Development Permit Panel

MINUTES

1. **DEVELOPMENT PERMIT 18-838656**
(REDMS No. 6742472)

1. DEVELOPMENT PERMIT 19-881158

PROPOSED TOWNHOUSE AT 9340 GENERAL CURRIE RD RICHMOND BC SITE PLAN (1/F)

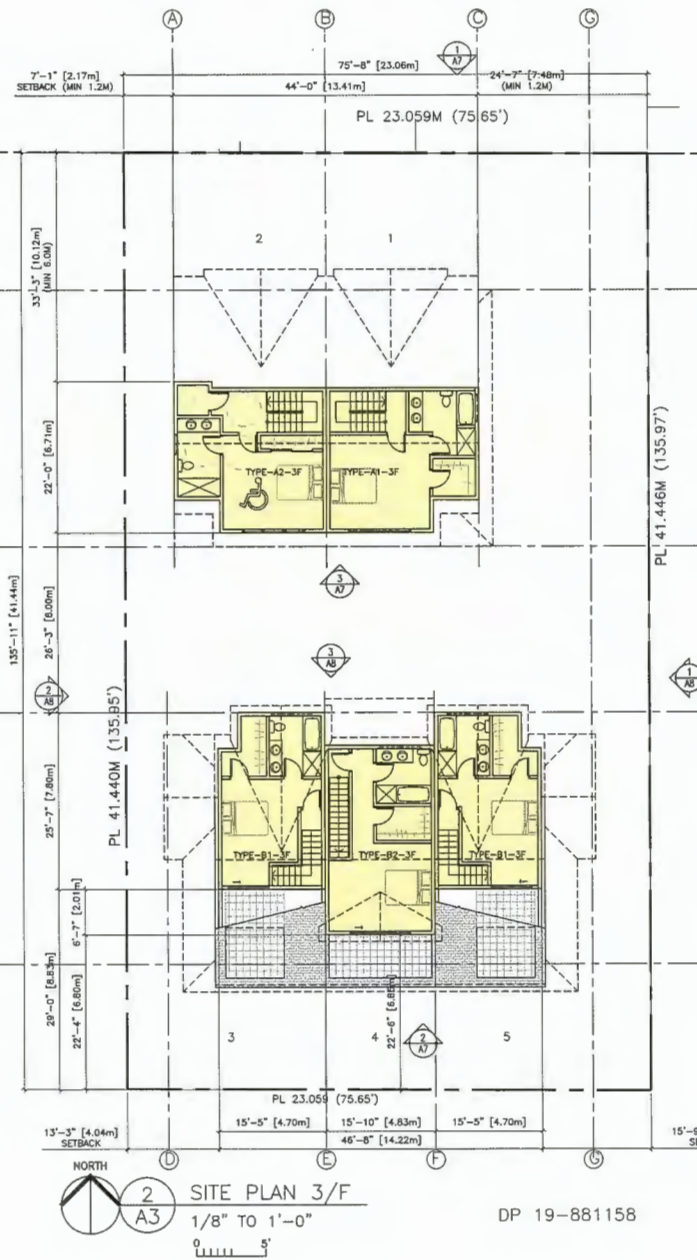
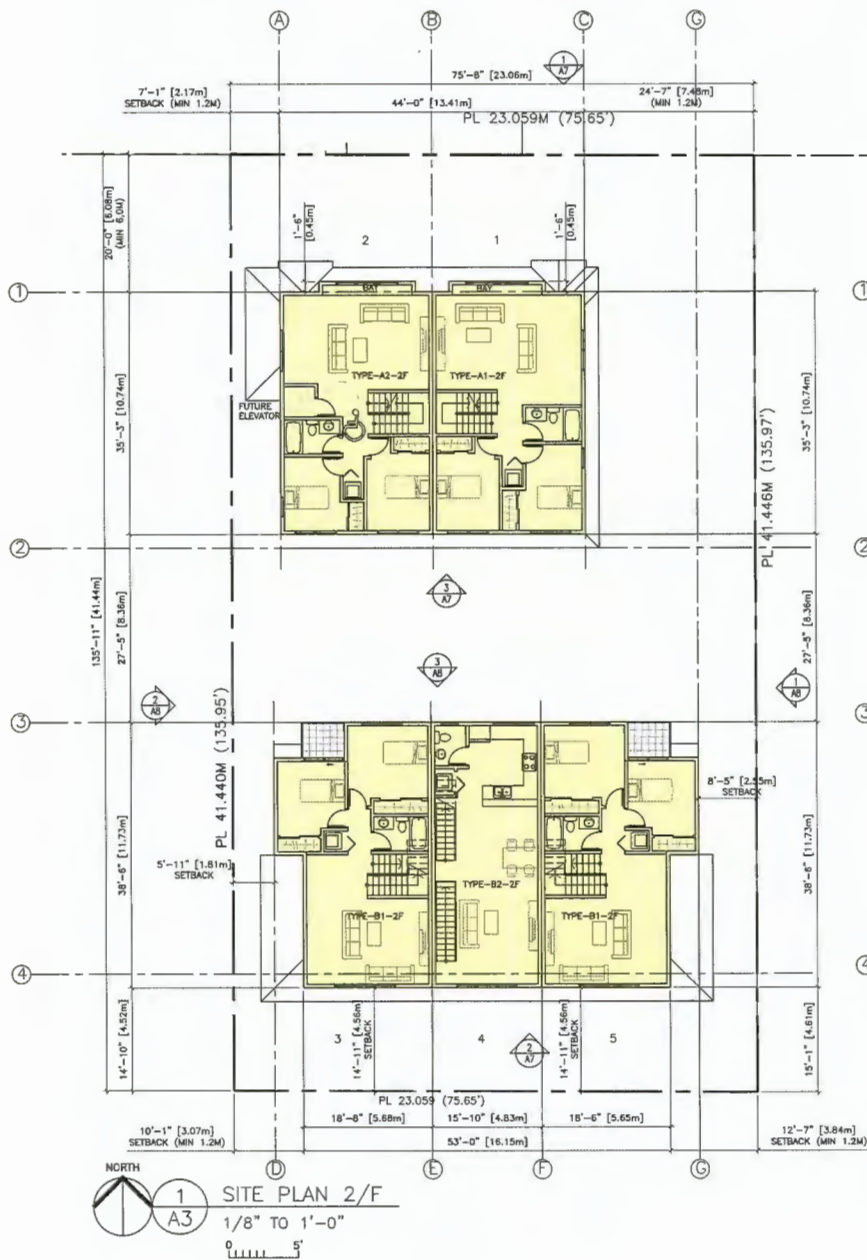
Discussion ensued regarding options and potential revisions to the design of the gable roof on the front building to reduce its height and massing and improve its interface with the adjacent two-storey townhouse buildings to the west.

As a result of the discussion, staff was directed to work with the applicant to investigate opportunities to revise the design the gable roof on the front building, including considering a clipped gable roof design.

**DP 18-838656
PLAN # 1.F
OCT 20, 2021**

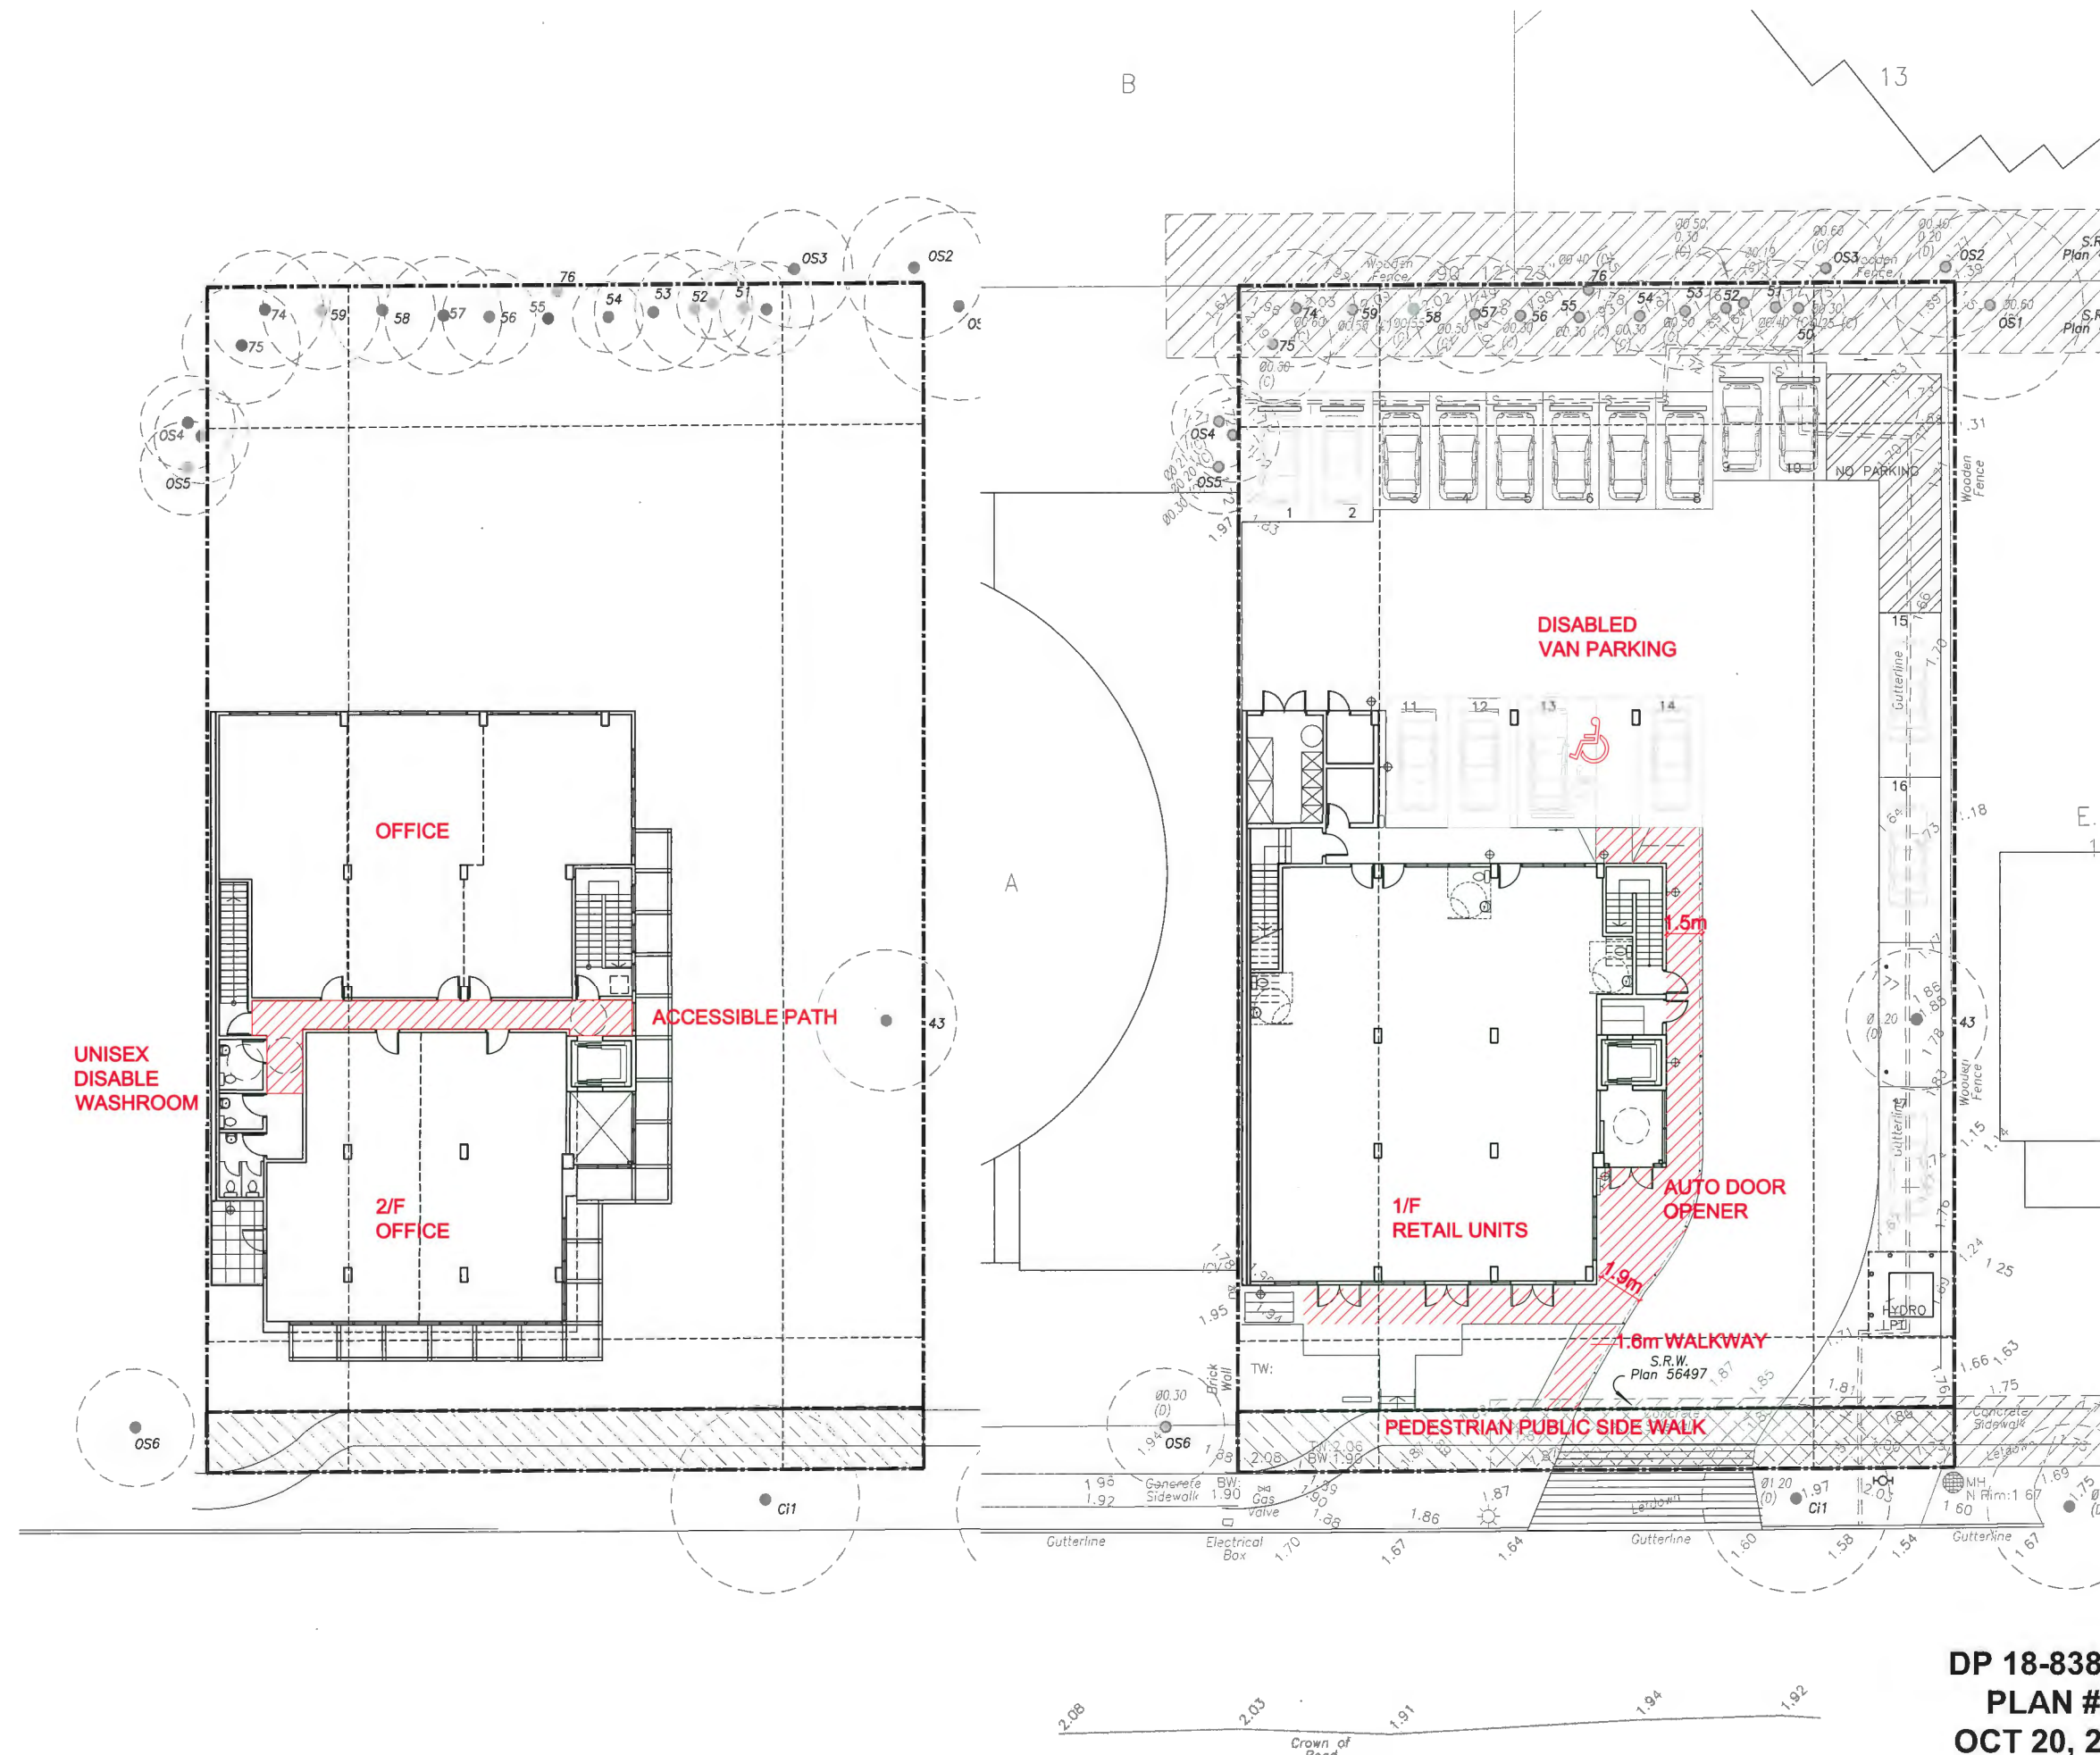
- The applicant has identified that the proposed design responds to the following accessibility principles, as shown on Plan # 1.F:
 - An accessible path of travel is provided to and from the storefront entries, lobby and van-accessible parking space.
 - The width of all on-site walkways is minimum 1.5 m wide and with a slope of no more than 4.8%.
 - The lobby is equipped with a power door operator and elevator.

3 L1 TRELLIS STRUCTURE-ALONG EAST PL

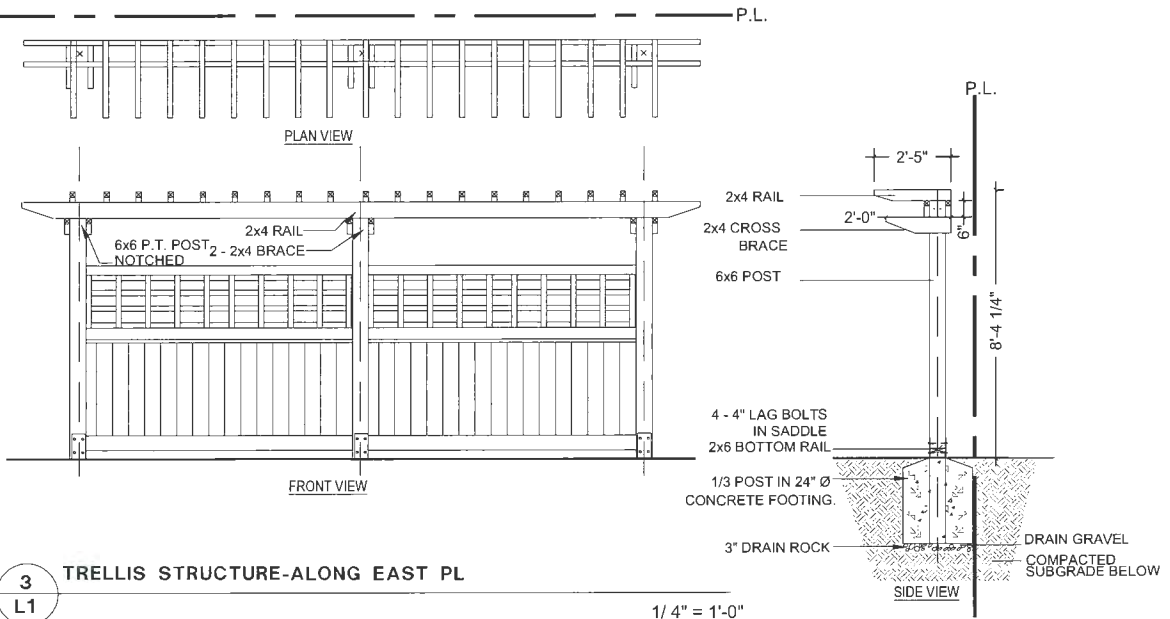
- consider introducing a taller structure, e.g. a trellis, to provide a buffer between the subject development and the two-storey duplex to the east and address overlook and privacy concerns; *A trellis structure is provided along east property line on L1*
